NOTICE OF PUBLIC HEARING
Minor Variance

APPLICATION NO.:	A-24:170	SUBJECT PROPERTY:	18 Howard Boulevard, Waterdown
ZONE:	"R1-6" (Urban Residential – Single Detached)	ZONING BY-LAW:	Flamborough Zoning By-law No. 90-145

GOLDBY RESIDENCE NEW SINGLE FAMILY DWELLING 18 HOWARD BOULEVARD WATERDOWN, ONTARIO

Re: Applicable Law Review – Zoning By-law Compliance
Zoning District: “R1-6” (Urban Residential – Single Detached) Zone
Zoning By-law: Flamborough Zoning By-law No. 90-145
Address: 18 Howard Boulevard, Hamilton

1 SITE PLAN SCALE: 1:100

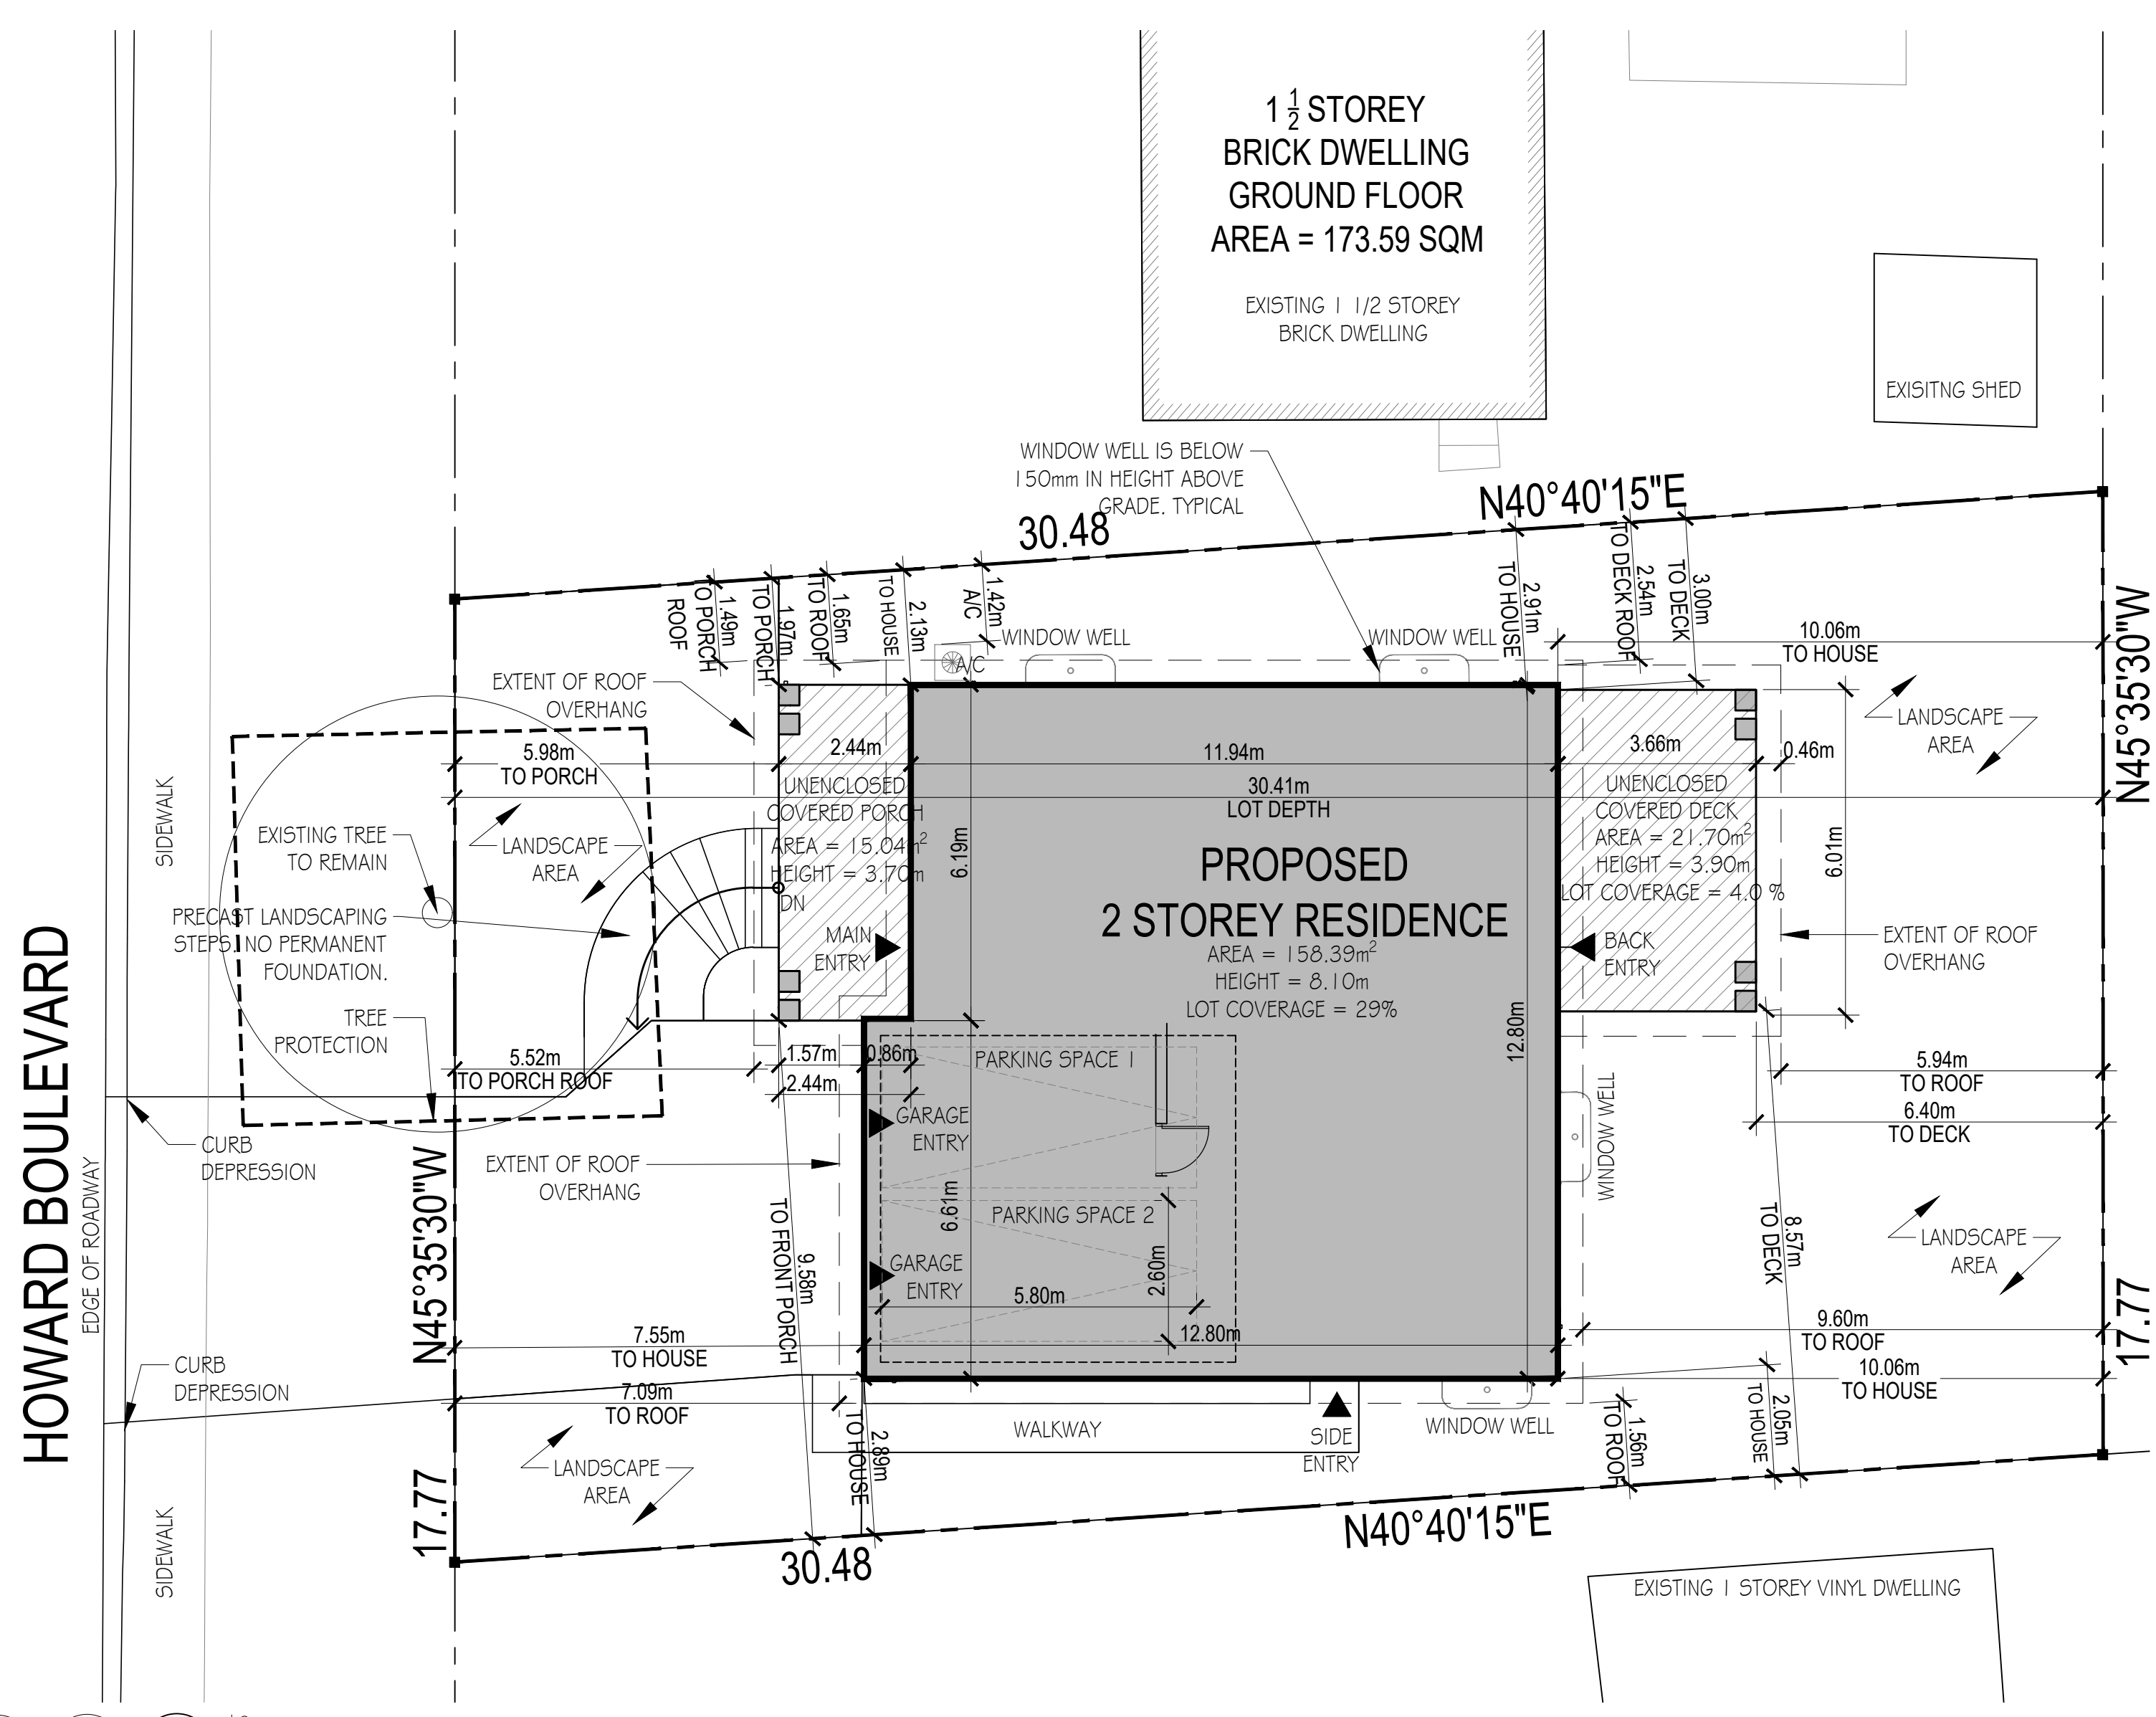
1. A maximum lot coverage of 33% shall be permitted, instead of the permitted maximum lot coverage of 15% [Section 6.3.6(d)]
2. A minimum northerly interior side yard of 2.10 metres shall be permitted, instead of the minimum 3.0 metres required. [Section 6.3.6(e)]
3. A minimum southerly interior side yard of 2.0 metres shall be permitted, instead of the minimum 3.0 metres required. [Section 6.3.6(e)]
4. An unenclosed porch, including eaves/gutters, shall be permitted to encroach 0.61 metres into the northerly required interior side yard, instead of the requirement that an unenclosed porch is not permitted to encroach into a required interior side yard. [Section 5.30]
5. An unenclosed porch, including eaves/gutters, shall be permitted to encroach 1.98 metres into the required front yard, instead of the maximum permitted encroachment of 1.5 metres. [Section 5.30]

- iv. Should the variance be granted to Section 6.3.6(e) to permit a minimum northerly interior side yard of 2.10 metres, the unenclosed covered deck at the rear of the dwelling would no longer encroach into the required northern interior side yard, and would be in compliance.

- v. Should the variance be granted to Section 6.3.6(e) to permit reduced minimum interior northerly and southerly side yards, eaves/gutters of the principle dwelling, which are indicated as projecting 0.46 metres, would be in compliance.

- vi. Should a variance be granted to permit a minimum northerly interior side yard of 2.10 metres, the unenclosed covered porch at the front of the dwelling, including the eaves/troughs, would encroach 0.61 metres in the required northerly side yard. Therefore, Variance No. 4 has been requested to permit the unenclosed covered porch to encroach 0.61 metres into the northerly interior side yard.

- vii. Please note that the applicant confirmed via email dated July 17th, 2024, that the stairs in the front yard are not connected to the unenclosed covered porch at the front of the dwelling, and therefore have not been considered to be part of the porch structure.
